UNITED STATES PATENT AND TRADEMARK OFFICE

| APPLICATION NO. | FILING DATE | FIRST NAMED INVENTOR | ATTORNEY DOCKET NO. | CONFIRMATION NO. |
|--|-------------|----------------------|---------------------|------------------|
| 10/642,343 | 08/18/2003 | Josef Giessler | 029777-015 | 1920 |

| Office Action Summary | Application No. 10/642,343 | Applicant(s) GIESSLER ET AL. | |

DETAILED ACTION

FIG. 5B

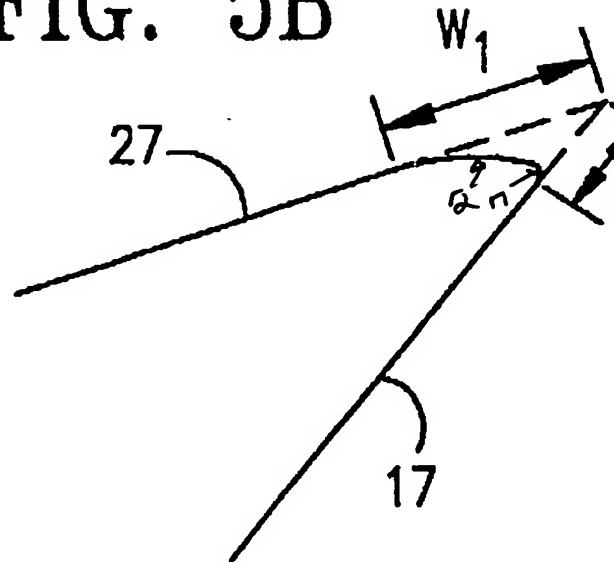
BRITZKE ET AL. teaches a rotary cutting tool/drill (10) comprising a shank (11) and a cutting part (13) disposed at the front end of the shank and defining an axis of rotation (16) and an outer periphery of the cutting part (13) having cutting grooves (15) extending helically to the front end face of the cutting part and each cutting groove disposed rearwardly of the end face defining a helix angle with a plane containing the axis while having cutting edges formed at the edge ('447, Figure 1 and Col. 3, lines 26-38). Regarding claim 1, BRITZKE ET AL. teaches the invention could be used on other tools such as milling cutters therefore, broadly reading the claim, it reads on "a shank end mill" ('447, Col. 5, lines 53-59). BRITZKE ET AL. also teaches in figures 5, the helix angle being larger than a cutting-face angle formed between the end face and a front end section of each cutting groove, the cutting-face angle continuously transforming into the helix angle. BRITZKE ET AL. also teaches in figures 5 the cutting-face angle transforming (via a transition) into the helix angle along a constant radius of curvature (figure 5A) as well as the cutting-face angle transforming into the helix angle along a plurality of radii (figure 5B) whereby a first radius adjoins the cutting edge, and a second radius adjoins the helix angle (the first radius being smaller than the second radius: see figure below). Regarding claims 5 and 6, BRITZKE ET AL. teaches in Figure 5B, the transition between the cutting-face angle and the helix angle extending substantially parallel to the axis for a distance shorter than a diameter of the tool as well as shorter than half the diameter of the tool (all see figure 4 for the diameter of the tool). Regarding claims 9 and 10, BRITZKE ET AL. teaches the rotary cutting g tool comprising a drilling tool or a milling tool ('447, Col. 5, lines 55-59).

However, BRITZKE ET AL. fails to teach the milling cutter being an end mill having main cutting edges extending along an edge of the cutting grooves as well as being arranged substantially in a common plane.

Sato et al. teaches an end mill having a shank (12) and a cutting part having cutting edges extending along an edge of the cutting grooves and being arranged substantially in a common plane ('409, figure 1 and page 1, paragraph 2).

Therefore, it would have been obvious to one of ordinary skill in the art at the time of the invention was made to include cutting edges that extending along an edge of the cutting grooves (and arranged substantially in a common plane) of BRITZKE ET AL's invention, as taught by Sato et al., for the purpose of using the tool in slot or shoulder milling operations ('490, page 1, paragraph 2, lines 6-7) since BRITZKE ET AL. teaches the invention can be used on other tools such as milling cutters ('447, Col. 5, lines 53-59).
